Baridhi Garments Limited

SFB#7, Comilla Export Processing Zone, Comilla, Bangladesh
(23.444001N, 91.183039E)

20th June 2016

Observations

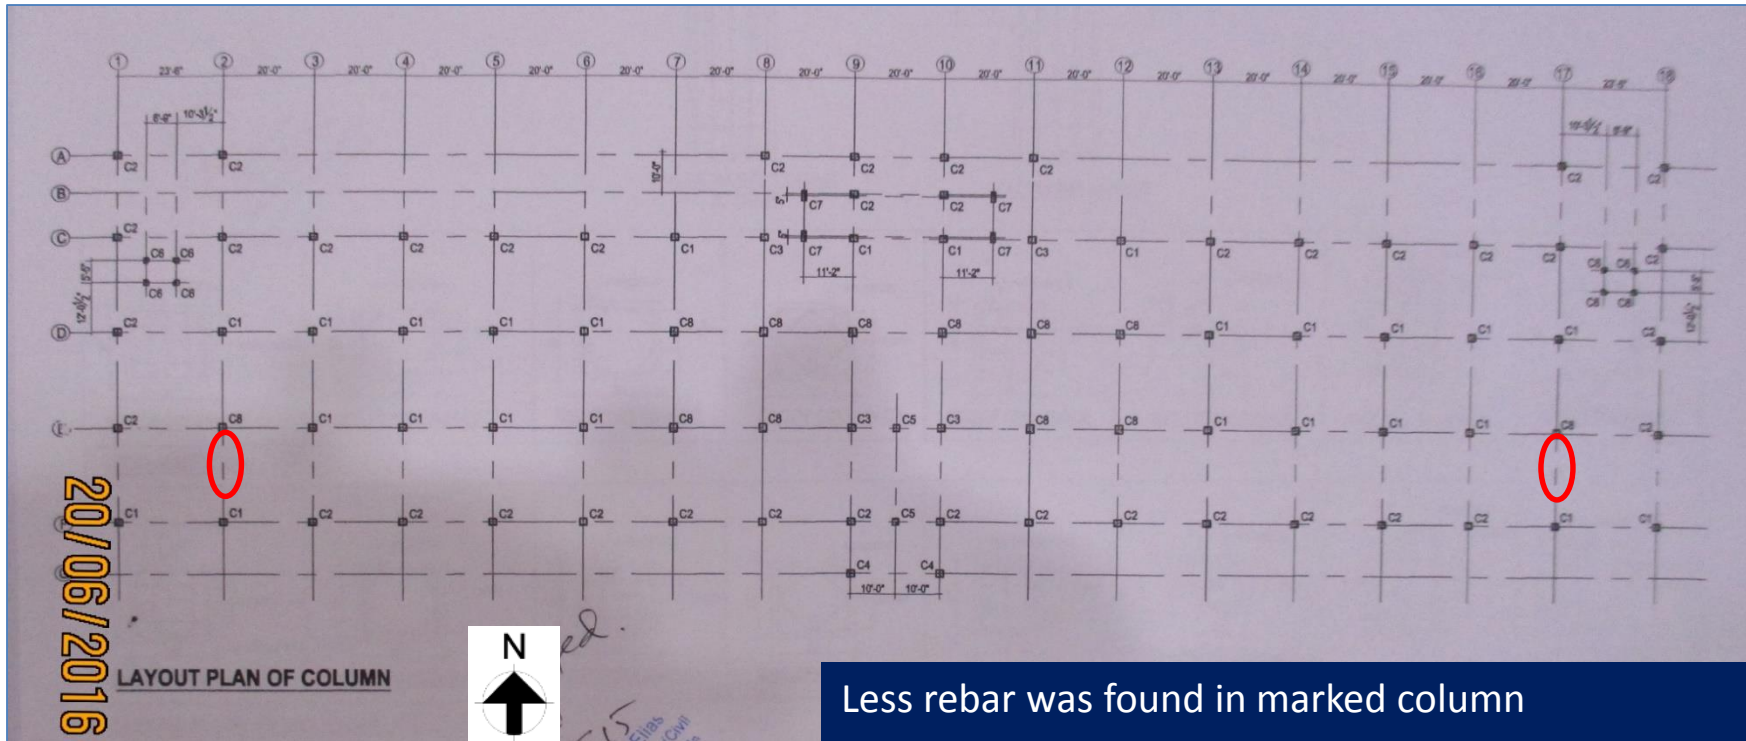
Detail scan found 4 rebar on one side but column schedule shows 5 rebar on both side.

Less rebar was found in marked column
